Model: Kir-C Paper Tray Unit / 1-tray (PS460)		Date: 22-Oct-01	No.: MB385001
Modified Article: Guide Plate Cushion		Prepared by: K. Miura	
From: Technical Services Dept., GTS Division			
Reason for Modification:	☐ Parts catalog correction ☐ To facilitate assembly ☐ Part standardization	☐ Vendor change ☒ To improve reliability ☐ Other	☐ To meet standards ()

Model: Kir-C Paper Tray Unit/1-tray (PS460)		Date: 27-Dec-02	No.: MB385002
Modified Article: Interface Board		Prepared by: K. Miura	
From: Technical Services Sec. Service Planning Dept.			
Reason for Modification:	☐ Parts catalog correction ☐ To facilitate assembly ☒ Part standardization	☐ Vendor change ☐ To improve reliability ☐ Other	☐ To meet standards ()

Model: Kir-C Paper Tray Unit/1-tray (PS460)		Date: 22-Dec-08	No.: MB385003
Modified Article: DC Motor		Prepared by: Y.Yoshida	
From: 1st Tech. Supprt Sec. Service Support Dept.			
Reason for Modification:	☐ Parts catalog correction ☐ To facilitate assembly ☐ Part standardization	☒ Vendor change ☐ To improve reliability ☐ Other	☐ To meet standards ()

Model: Kir-C Paper Tray Unit/1-tray (PS460)	Date: 22-Dec-08	No.: MB385003
---	-----------------	---------------

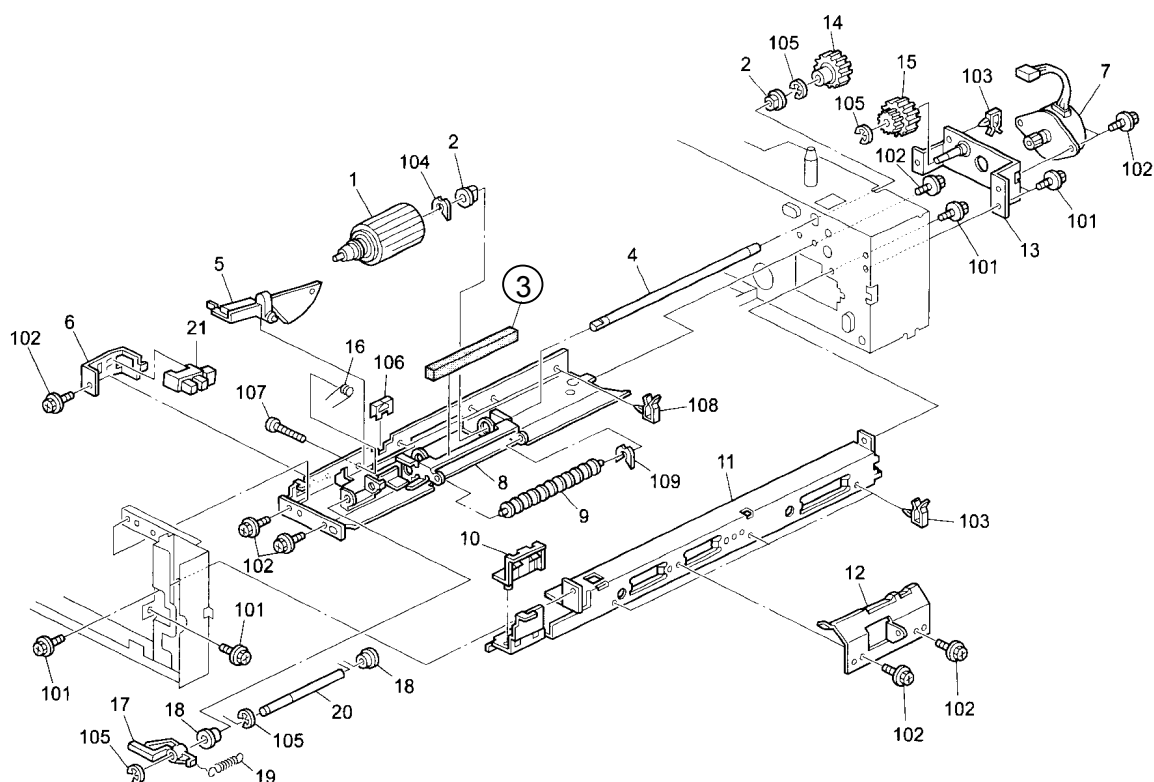
The following part has been changed to ensure that noise does not occur during paper feed.

Old part number	New part number	Description	Q'ty	Int	Page	Index	Note
A8602559	B3852559	Cushion Guide Plate	1	O/O	7	3

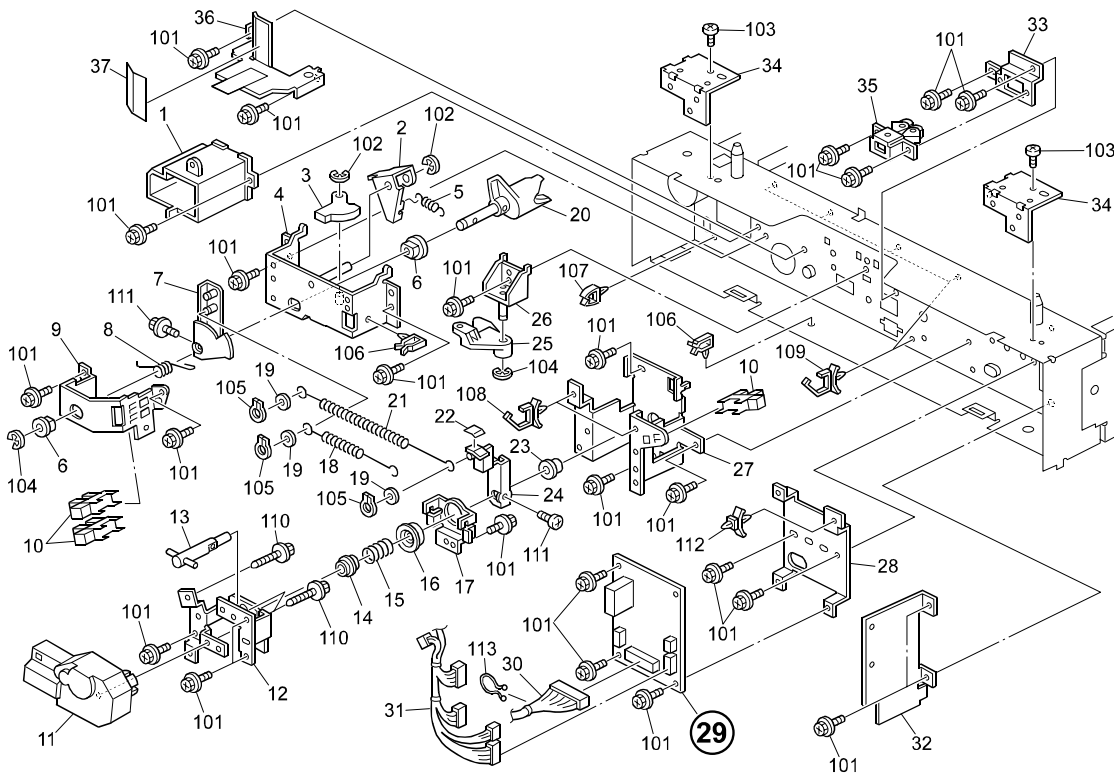
The following part has been changed due to parts standardization with future models.

Old part number	New part number	Description	Q'ty	Int	Page	Index	Note
A8615110	B3855110	Interface Board	1	O/O	9	29

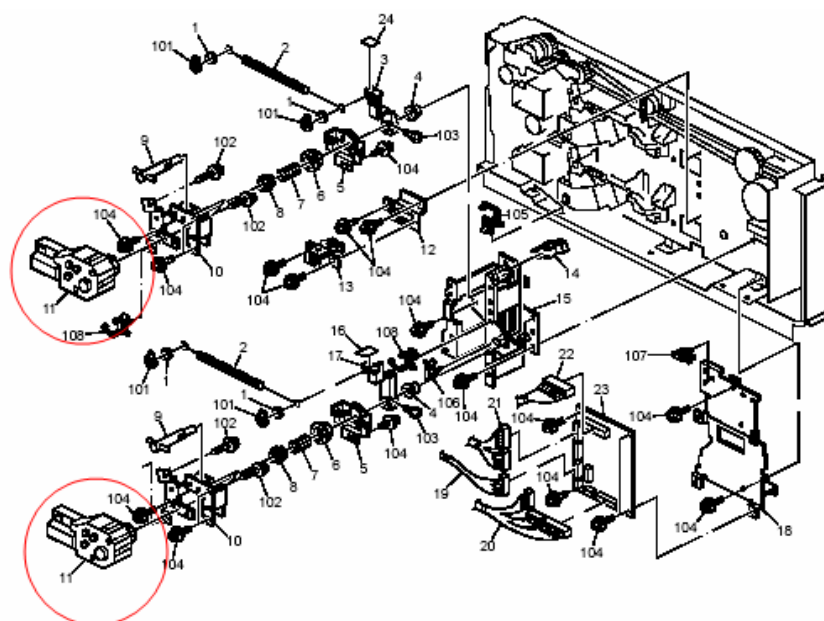
Old part number	New part number	Description	Q'ty	Int	Page	Index	Note
AX040220	D3312680	DC Motor: Paper Feed:Ass'y	1	O/O	9	11

Change/Reason: Vendor change.

Important: See the replacement procedure on the next page.

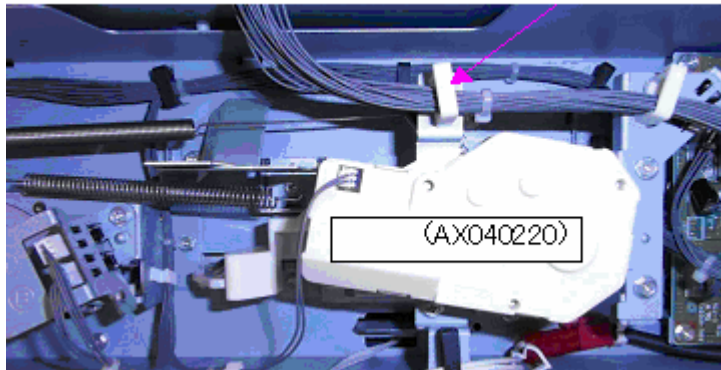
1. Take out the clamp [A].

Take out the clamp (A)

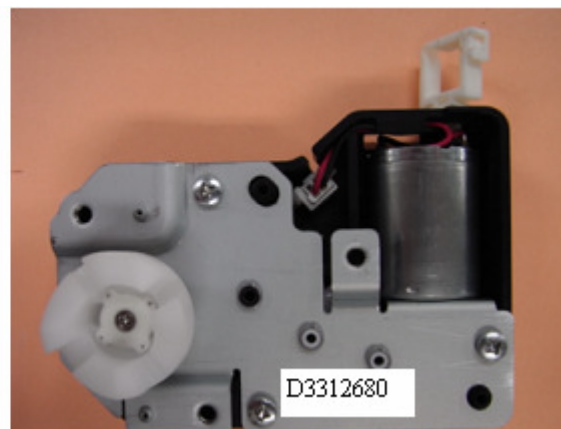
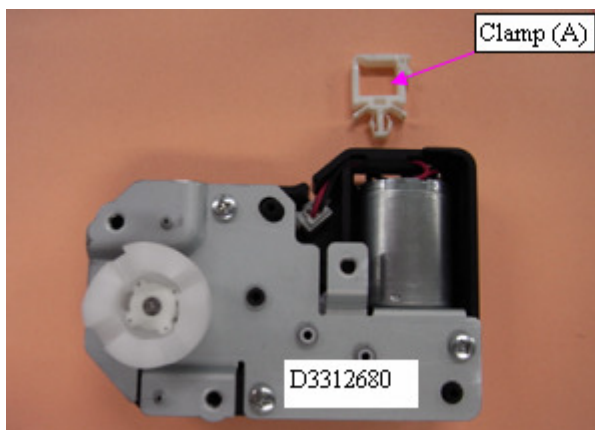
2. Attach the new clamp [A] to the new DC motor.

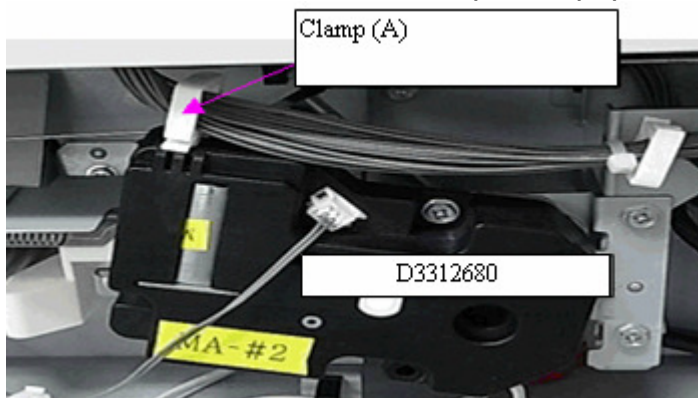
3. Attach the new motor to the optional paper tray unit.
